SB-10044066-3037

Title: Block Heater Element Hitting the Front Crossmember**Applies To: 7600 with 2010 EPA Maxx Force 11 and 13 with feature code 0012864**

Figure 1

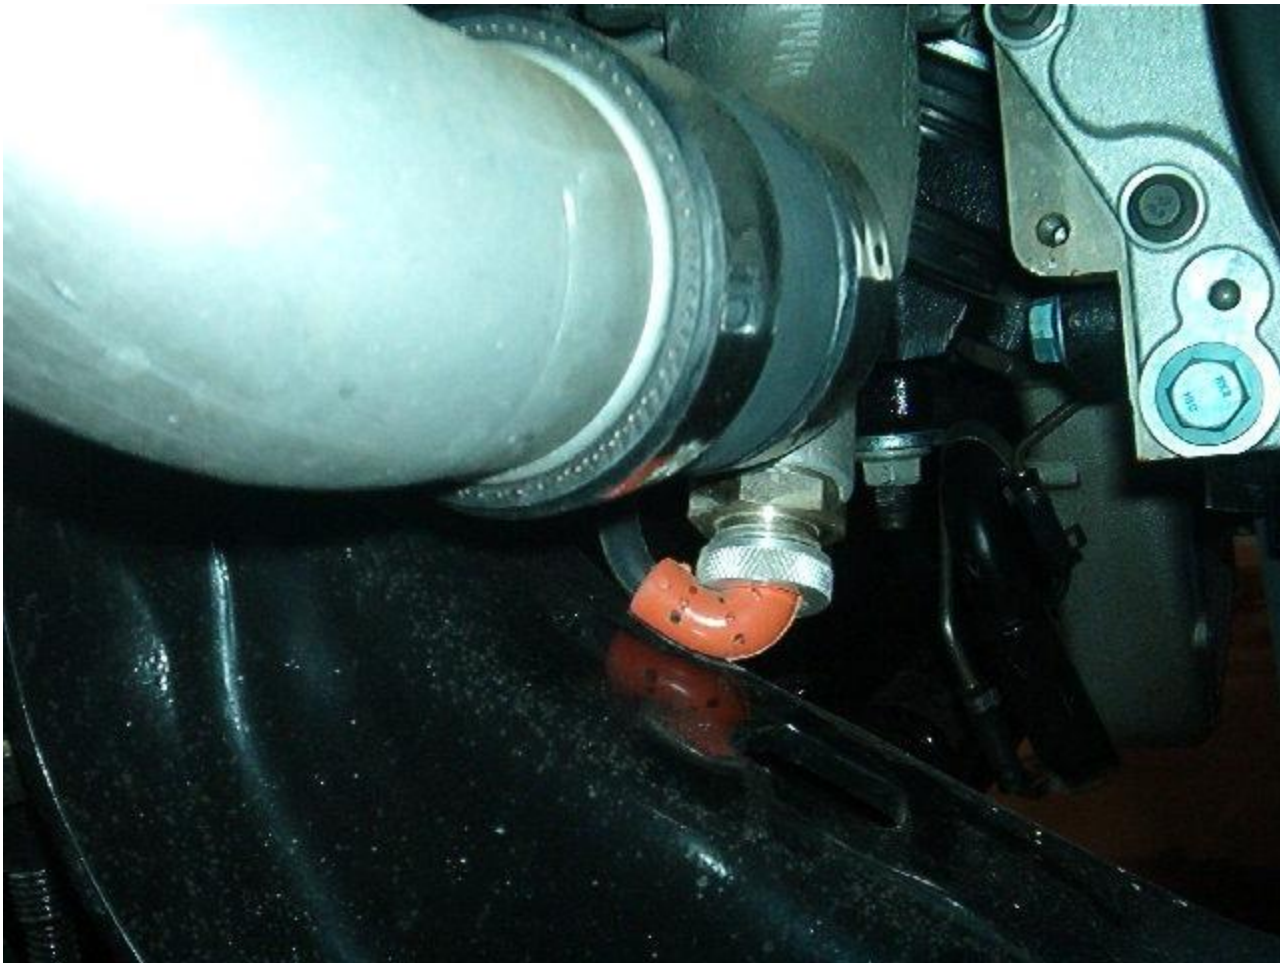
The below information is the repair for the block heater element coming in contact with the front crossmember.

Figure 2

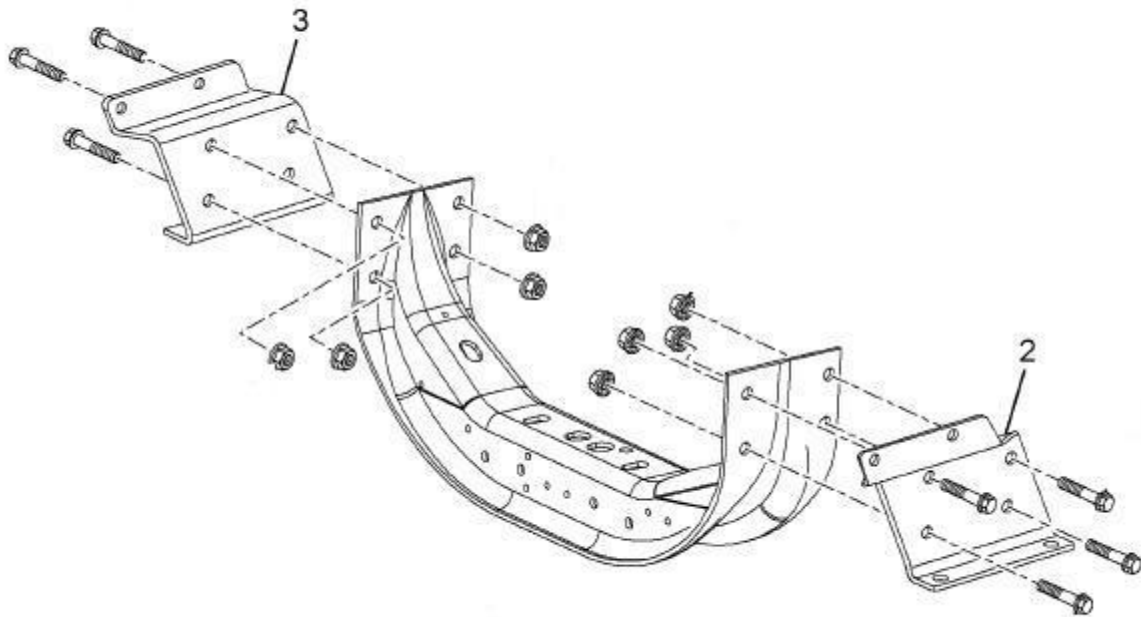
The brackets for the front crossmember (items 2 and 3 in figure 2) need replaced with the above provided C2 part numbers. The new C2 brackets have the holes for the crossmember mounting placed lower. This lowers the crossmember increasing the clearance from the block heater element.

Part #	Description	Qty.
3727831C2	Bracket	1
3727832C2	Bracket	1
